STORMWATER ENGINEER COMMENTS

SUTHERLAND SHIRE COUNCIL

TO: Carolyn King
FROM: Guy C Amos
DATE: 10 January 2010
FILE REF: DN10/0007
SUBJECT: 566-594 Princes Highway, Kirrawee – Flooding and Stormwater

TO:	Carolyn King - Development Assessment Officer Ext - 5846
FROM:	Claudia Miro – Senior Heritage Architect Ext - 5181
DATE:	05 January 2011
FILE REF:	DN10/0007
SUBJECT:	Application No. DN10/0007 Description: Concept Plan for Mixed Use Residential and Commercial Development at 566-594 Princes Highway, Kirrawee Brick Pit, Kirrawee Property: 566-594 Princes Highway KIRRAWEE NSW 2232

Figure 1 – Location of the brick pit and downstream catchments currently identified to be at risk of flooding.

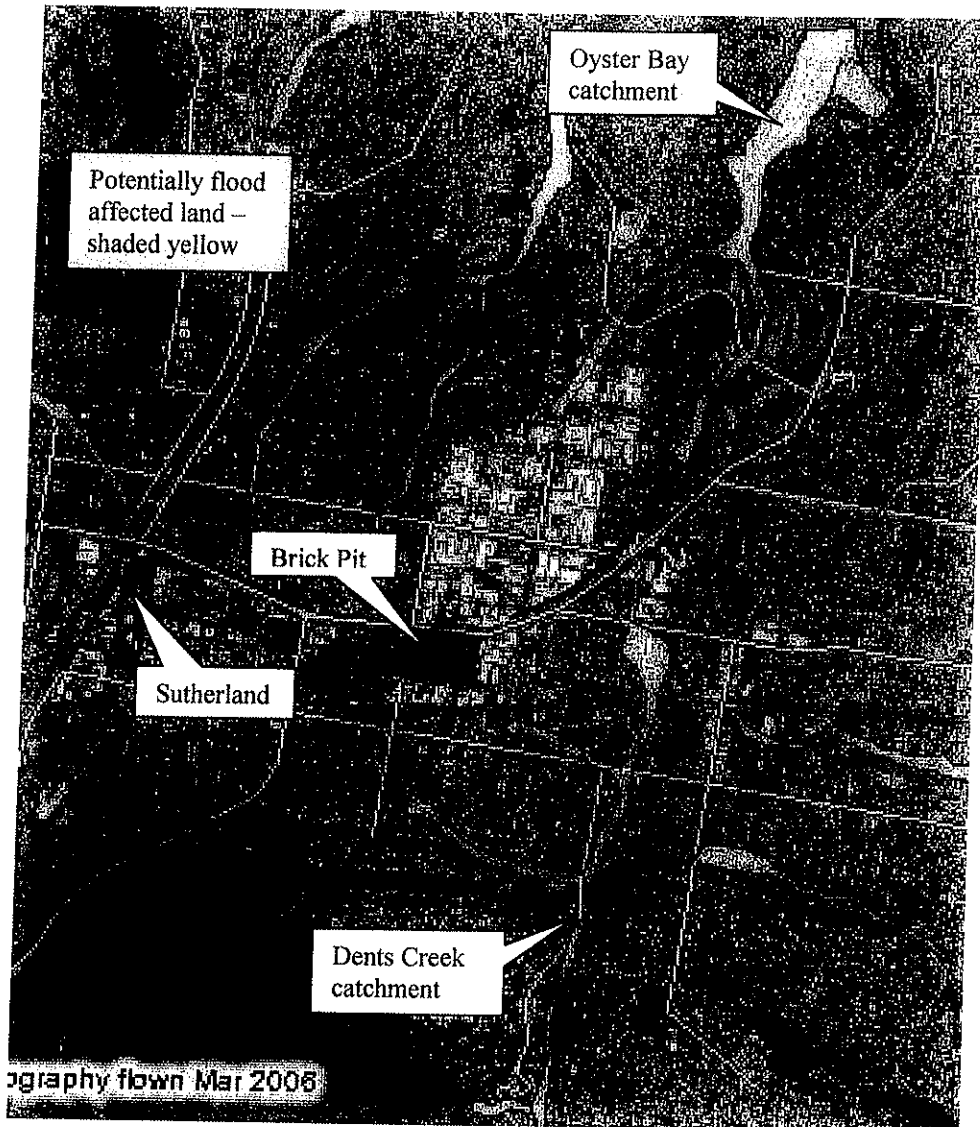
Northrop advocates discharging stormwater from the northern one third (1/3) of the site to Oyster Bay catchment and the southern two thirds (2/3) of the site to Dents Creek catchment. **Figure 1** shows the location of the brick pit and downstream catchments currently at risk of flooding. While it is intended to limit the rate of stormwater flow from the proposed development through construction of large On-Site Detention (OSD) tanks, they do not appear to have been integrated into the overall urban design. Further, the suggested OSD capacity is not adequate to ensure that downstream public and private assets will not be subject to increased flooding as a consequence of the proposed development. The applicant had agreed to a maximum rate of stormwater flow to address Council's concerns, but is now proposing to discharge 0.52 m³/sec or 520 litres/sec from the southern 2/3 of the site – This is not acceptable. The extent and risk of flooding downstream needs to be fully identified along with what works would be required to upgrade the public drainage network at the developer's cost to compensate for the likely stormwater discharge from the proposed development.

(diagram from Conservation Management Plan and Heritage Impact Statement for Pipe Kiln at former Brickworks by Edward Higginbotham, 27 October 2010)

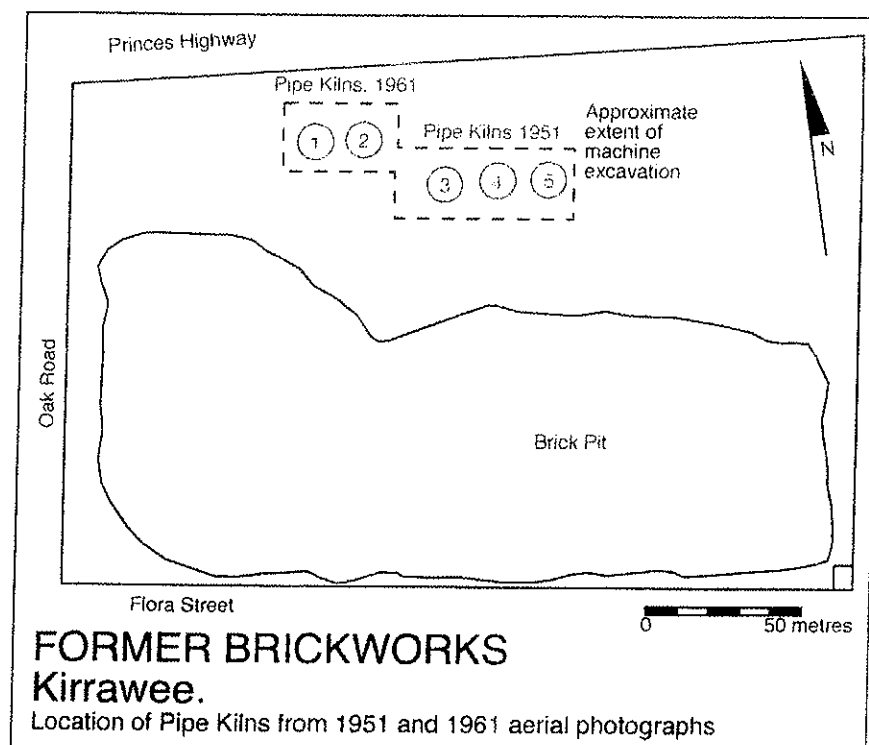
1. Conservation in situ of "Beehive" or down draught pipe kiln, Kiln 1, as identified in the report as the one located western of the site, frontage to the Princess Highway and most intact. This option (Option 1) is compliant with the principles of the Burra Charter.

2. Conservation in situ of part of the brick pit and quarry walls to the west and south to retain the setting of the Kiln and strategies for its interpretation shall be incorporated to the Conservation Management Plan.
3. *Detailed works and policies related to conservation, interpretation and display of pipe Kiln 1 and its setting compromised by the brick pit, should be fully described in an Interpretation Plan, as required by Condition 16 of the excavation permit (21/11/2008).*
4. *An archaeological monitoring programme for the removal of fill layers during redevelopment should be undertaken to recover significant relics for interpretation and display.*
5. *Work to conserve Pipe Kiln 1 should be undertaken by persons with the relevant skills and trades, for example, archaeologist, engineer and person with skills in pipe kiln construction and repair.*
